ELECTRICAL CURRENTS

Newsletter from the Office of the Chief Electrical Inspector

Vol. 9 No. 4

April 2006

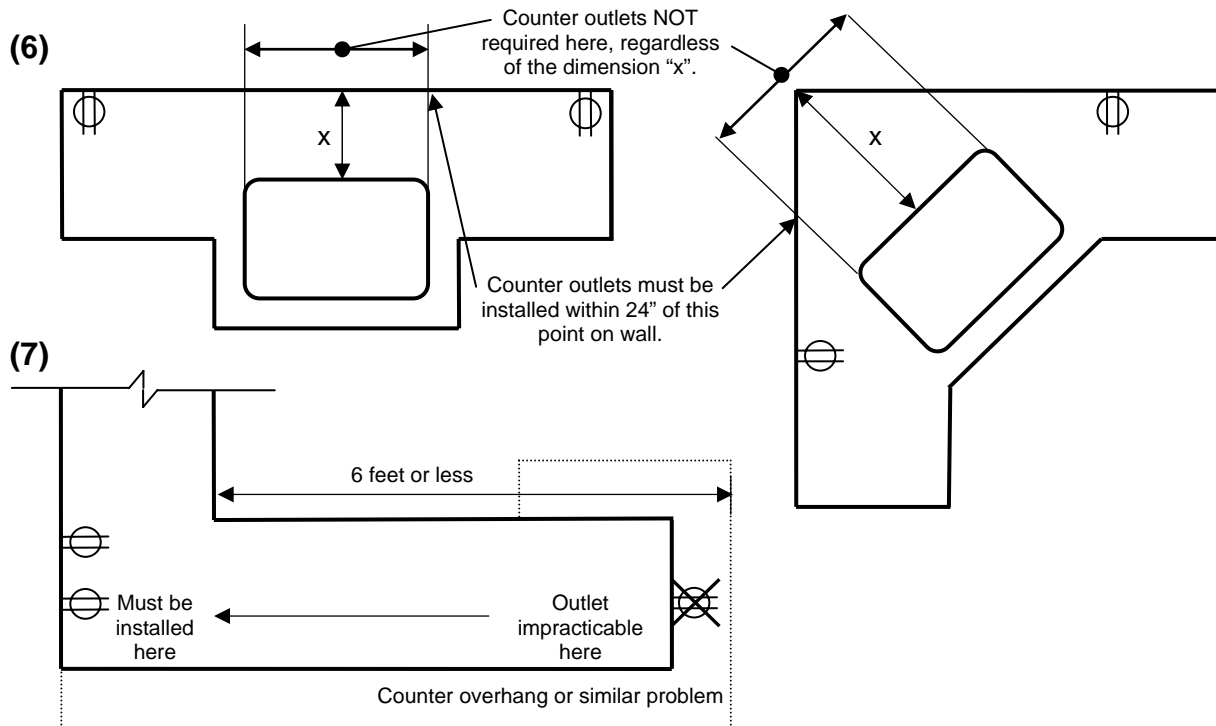
- In **WAC 296-46B-210(1)**, the definition of “kitchens in other than dwelling units” has been removed and the new definition in NEC 210.8(B)(2) will now be applied. The old rule specified “work surface for food or beverage preparation”, while the NEC now states “an area with a sink and permanent facilities for food preparation and cooking.”
- In **WAC 296-46B-210(6)** a counter outlet is not required behind a sink or range, no matter what the dimension “x” is in the diagram (6) below. If none is installed, then there must be a receptacle within 24” on either side of the sink or range as indicated in the diagram and NEC Figure 210.52.

- In **WAC 296-46B-210(7)**, if it is impracticable to install the peninsular counter outlet(s) required in the NEC, they may be eliminated so long as the peninsular counter area extends no farther than 6' from the face of the adjoining countertop. Check for approval from your inspector **prior** to relocating the outlets. Any outlet(s) eliminated must be installed in the wall space at the point where the peninsula connects to the wall, in addition to any that would normally be required in that wall space by the NEC. See diagram (7) above.
